**CITY COUNCIL STAFF REPORT**

Meeting Date June 23, 2025

**AGENDA ITEM:** Saint Paul Police Training Facility, 2621 Linwood Avenue East  
 a. Conditional Use Permit Resolution  
 b. Design Review Resolution  
 c. Wetland Buffer Variance Resolution

1 SITE PLAN

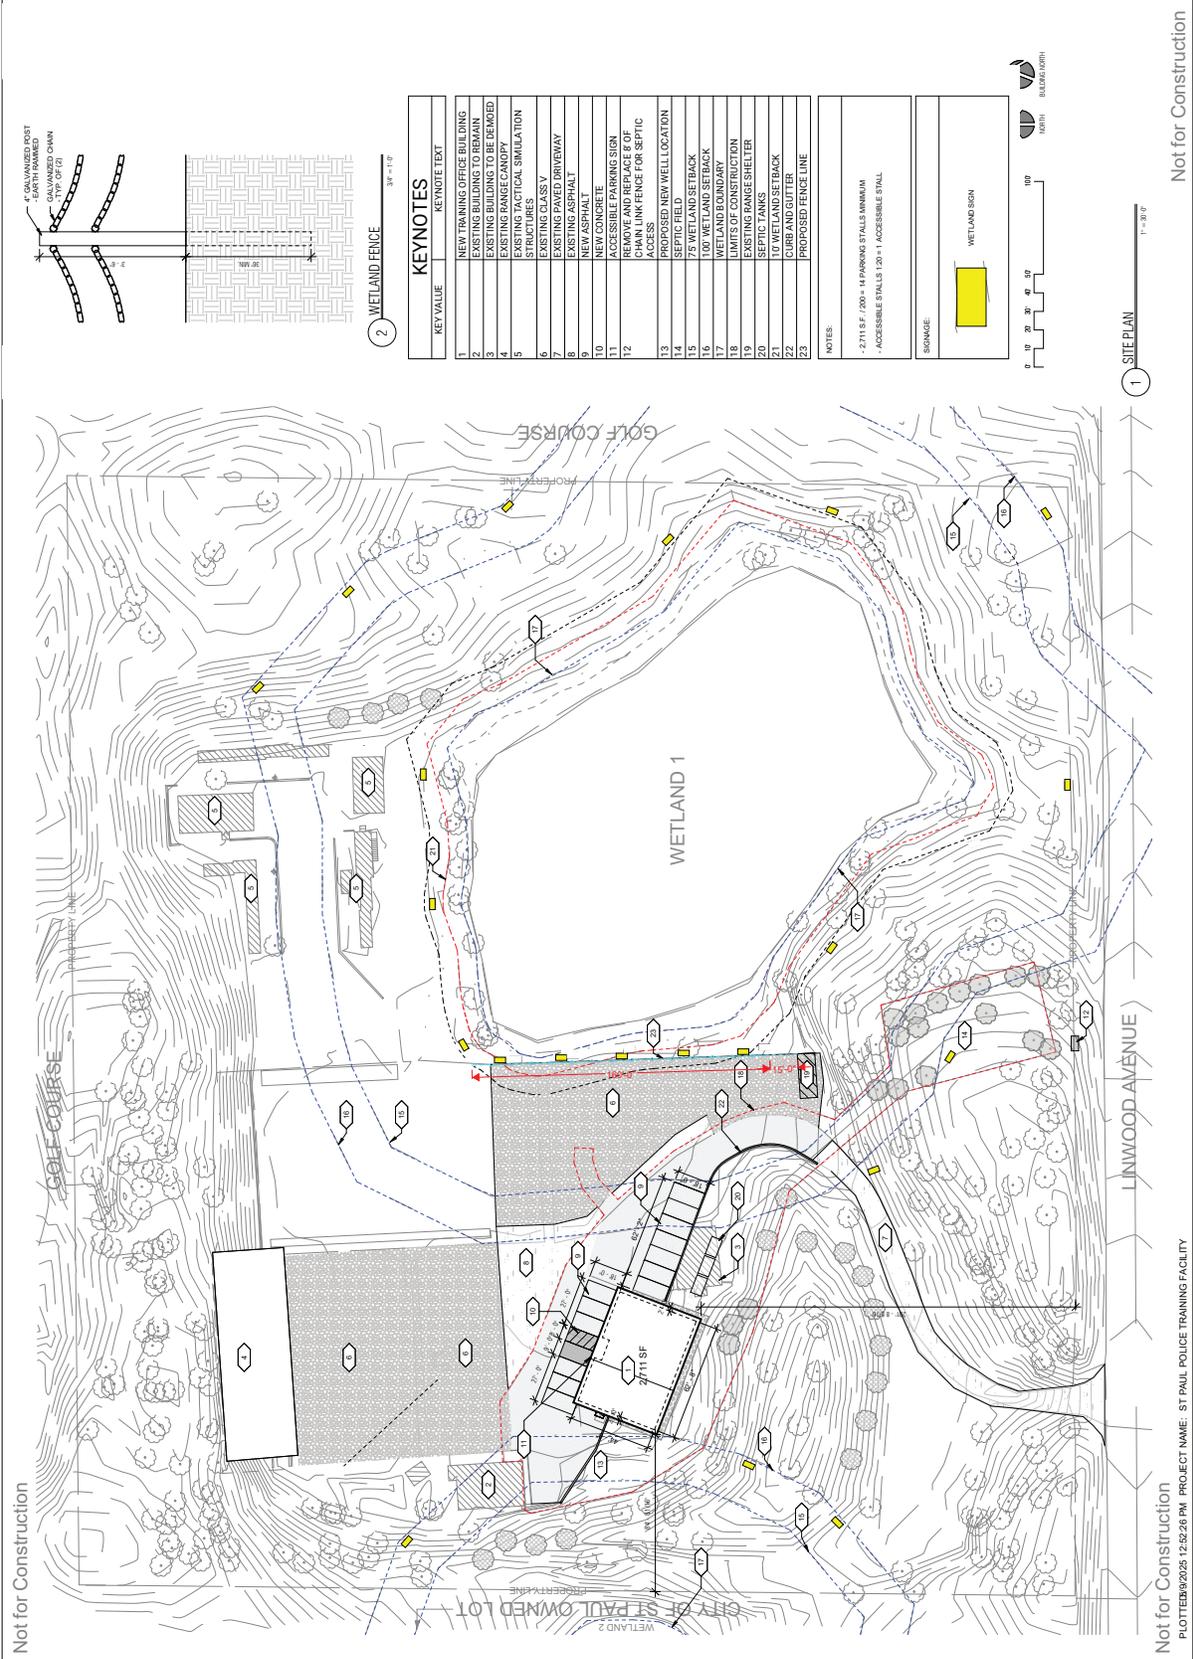
Our proposed project will locate a new building between the two buffer setbacks. 11 of the required parking stalls are between the buffers, with three stalls between the 75' and 100' buffer lines. The area of the encroaching parking stalls is on an existing paved area, with the project including improvement of the pavement to provide a slight regrading to allow for proper drainage of the area.

We request the proposed project be approved to encroach into the wetland buffer as shown on the attached site plans. The dimensions of encroachment vary and are dimensioned on the site plan, and summarized here:

1 LANDSCAPE PLAN 1" = 50'

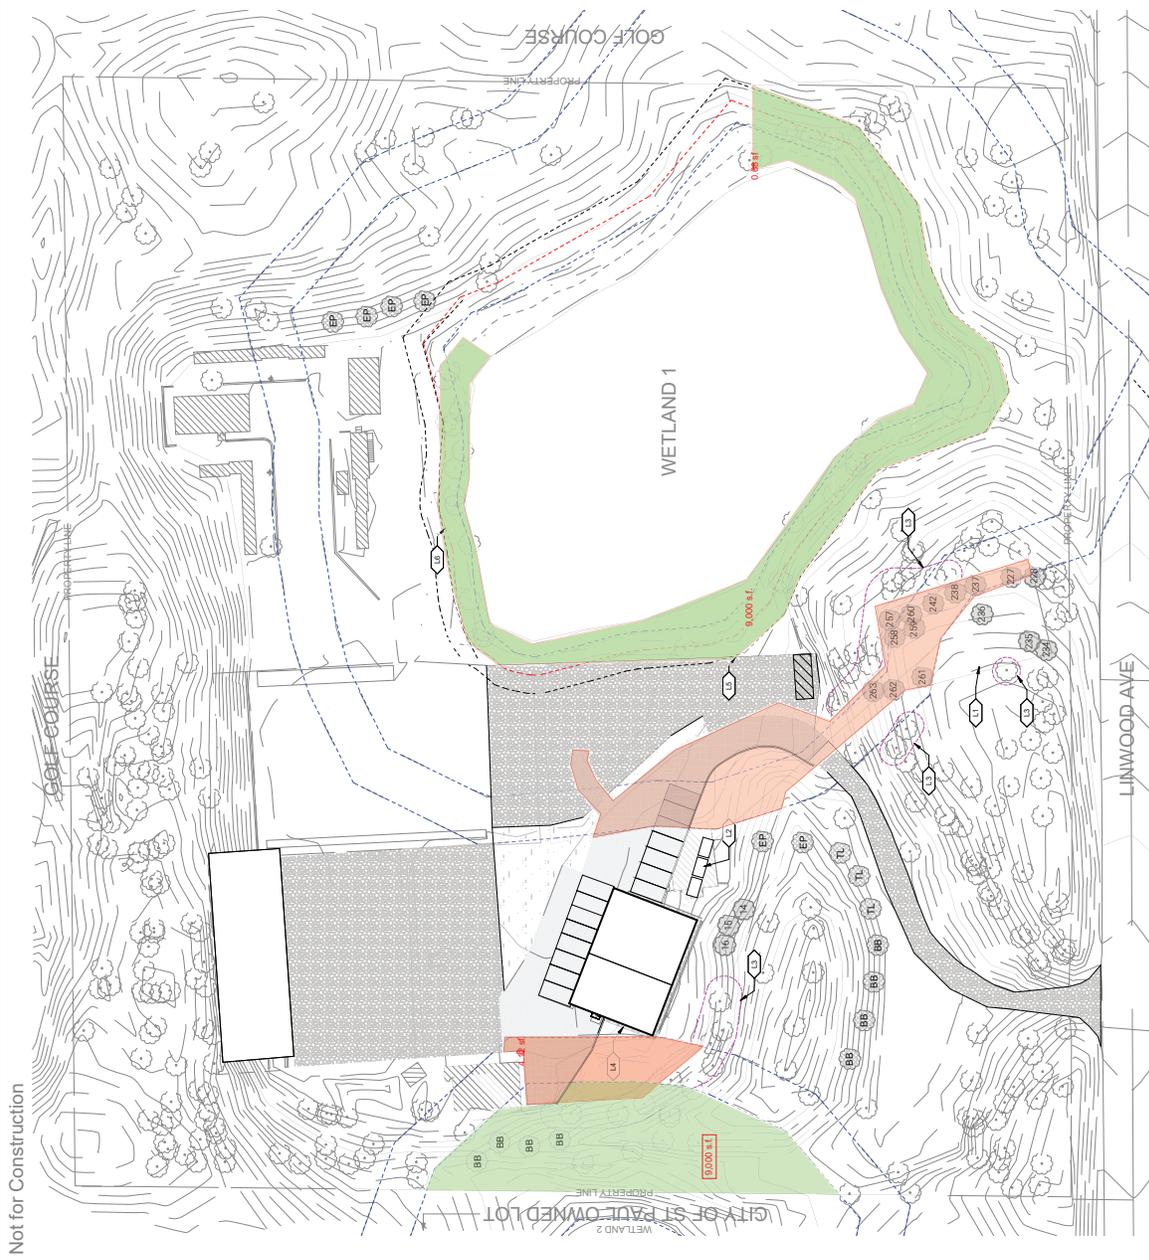
2. Tree Impacts: The tree survey identifies 308 significant trees on the site, however, the overall caliper inches of significant trees are not included. The site demolition plan shows the removal of 18 significant trees; however, the size and species of the trees are not included. Tree replacement cannot be determined without additional information, but it is likely that the tree removal is less than 20 percent of the overall caliper inches of trees on the site. In that case the required tree replacement is 18 – 2 diameter inch trees.

3. Tree Replacement: The landscape plan includes 18 – 2 diameter inch trees.

4. Tree Recommendations:
  - a. Prior to issuance of a grading permit the following is required:
    - 1) Tree Plan:
      - a) Identify which trees will be removed on the tree survey and the size and species on the site demolition plan.
      - b) Add the City's tree replacement calculation to the plans. The tree calculation will include the overall caliper inches of significant trees on the site versus the caliper inches of trees removed.
    - 2) Tree Planting Plan: Final tree planting plan to be reviewed and approved by the City's Natural Resources Coordinator.
    - 3) Tree Escrow: Tree escrow in the amount of \$60 per caliper inch of trees to be replaced on the site. The escrow will be released once the trees are planted with a one-year warranty.

- 1) Plan showing the square footage of wetland buffer impacts (grading and building) beyond the 100-foot required buffers.
    - 2) Plan showing the wetland buffer mitigation strategies equal 2 square feet of mitigation per 1 square foot of wetland buffer impact.

- 3) Plan showing the location of the removal of buckthorn and other nonnative species being proposed within the western wetland buffer.

- 4) Fence plan to include the materials, height, and location.
- 5) Revised landscape plan to include:
  - a) Detailed plan for nonnative plant removal and maintenance.

- b) Native seed mix or native plugs as necessary to fill in the areas on the north side of the eastern wetland (area called out as Zone 1A in the May 5 restoration plan) once the nonnative plants are removed.

- c) Detailed plan for new wetland buffers (areas called out as Zone 1A and Zone 2 in the May 5 restoration plan) including seed mix species and installation methods, and location and species of native plant plugs.
